# WATER QUALITY MEMORANDUM

Utah Coal Regulatory Program

RE: 2007 Fourth Quarter Water Monitoring, PacifiCorp, Trail Mountain Mine, C/015/0009, Recurring Task ID #2713

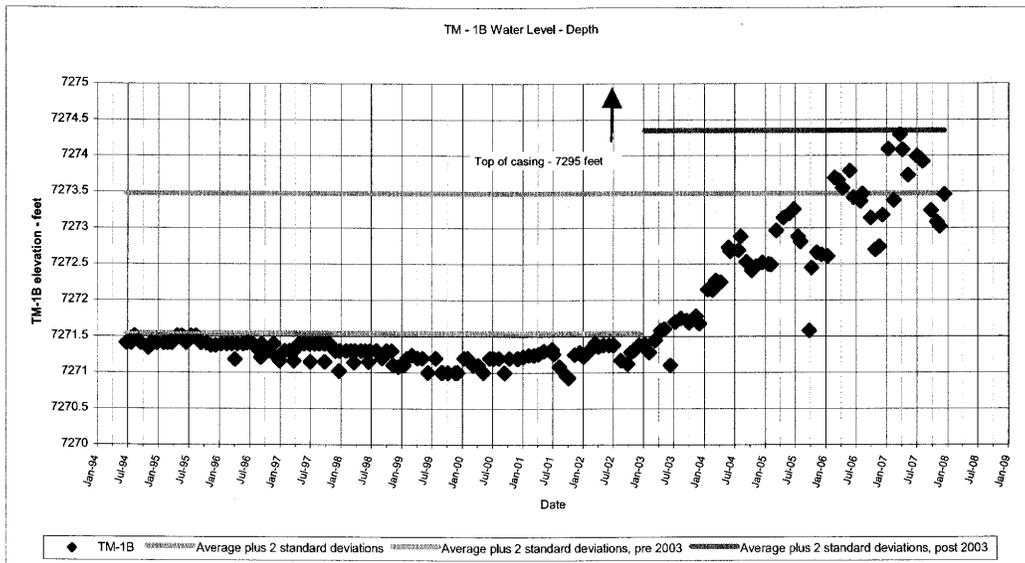
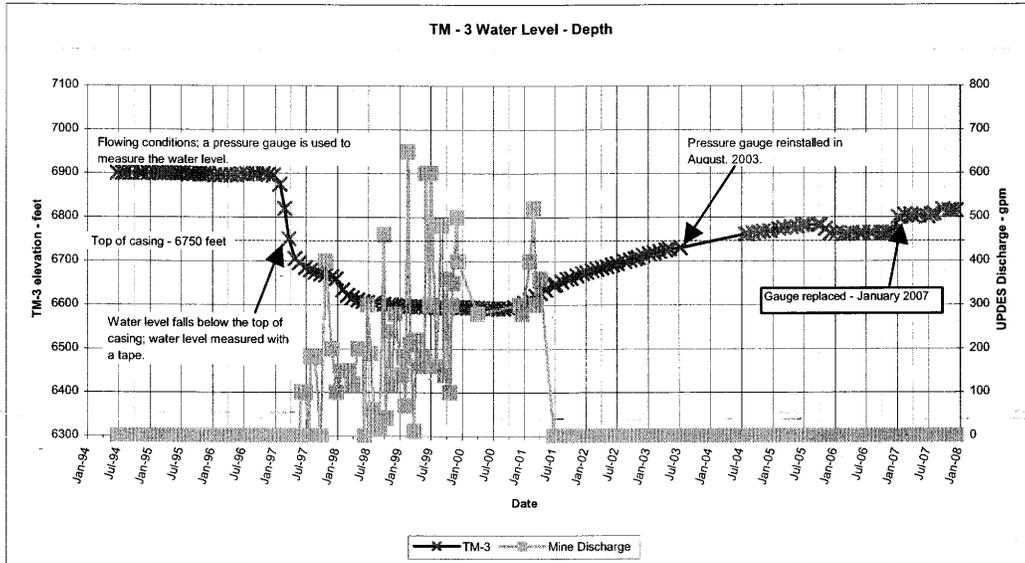
TM-3: water elevation peaked in June 2005, remained steady through October, dropped 18.5 ft in November and December 2005 and remained virtually unchanged during 2006. The pressure gauge was replaced in January 2007 and values jumped to approximately match the pre-2006 curve. During the first half of 2007, the curve was relatively flat, but it resumed climbing during the third quarter. Pressure was flat during the 4<sup>th</sup> quarter 2007: the Permittee should check the accuracy of the pressure gauge. See the chart below.

Pressure at TM-3 was flat during the 4<sup>th</sup> quarter 2007: the Permittee should check the accuracy of the pressure gauge.
